UNITED STATES PATENT AND TRADEMARK OFFICE

10/787,076

Office Action Summary

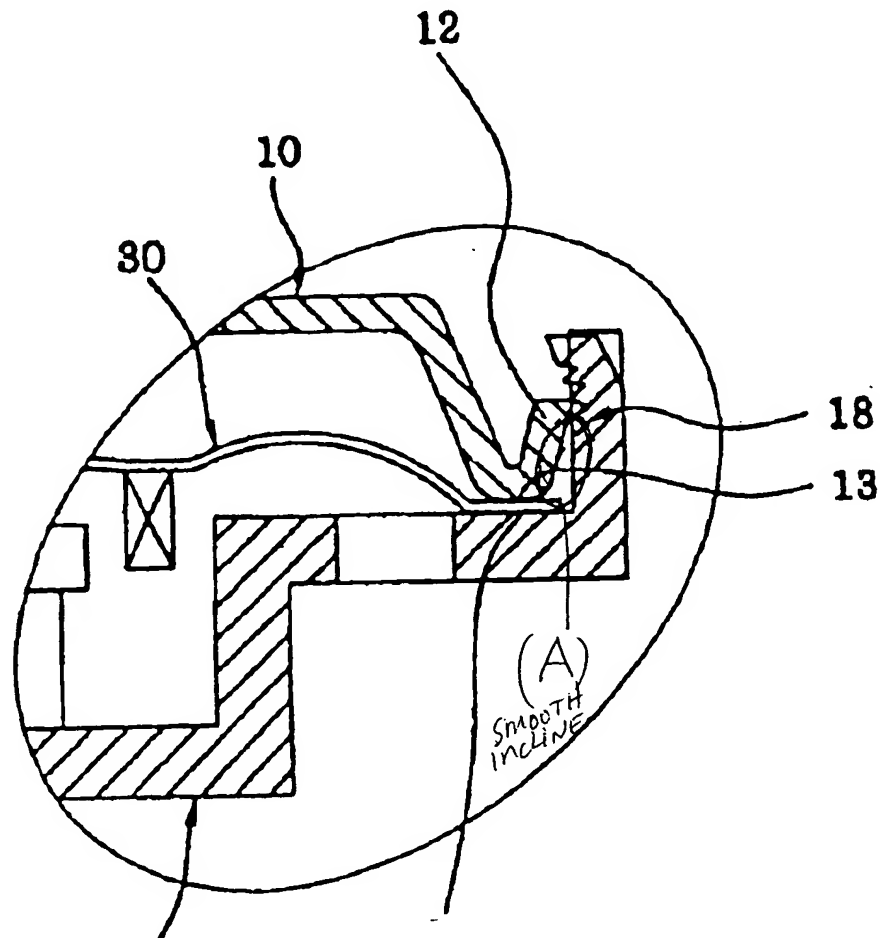
Regarding claim 1, in figure 5, Lee teaches a case for containing an electrical instrument, comprising: a frame 20 with a peripheral wall portion;

A cover member 10 having a peripheral wall portion 12 fitted on the wall portion of the frame 20 and configured to form a space for containing electrical instrument between the frame 20 and the cover member 10;

At least one hole 18 (each serration groove-18 is interpreted as providing "at least one hole" as claimed) provided in the peripheral wall portion of the frame 20, reading on "provided in one of the peripheral wall portions of the frame and the cover member to fix the frame and the cover member; and

A protrusion **12** provided on the peripheral wall portions of the cover member, reading on "provided on the other of the peripheral wall portions of the frame and the cover member for being inserted in said hole",

Wherein the protrusion **12** (see figure, below, provided by the Examiner) has a smoothly inclined surface **(A)** to guide the protrusion into the hole **18** so that the protrusion **12** is inserted in the hole smoothly to fix the frame **20** and the cover member **10**, as claimed.
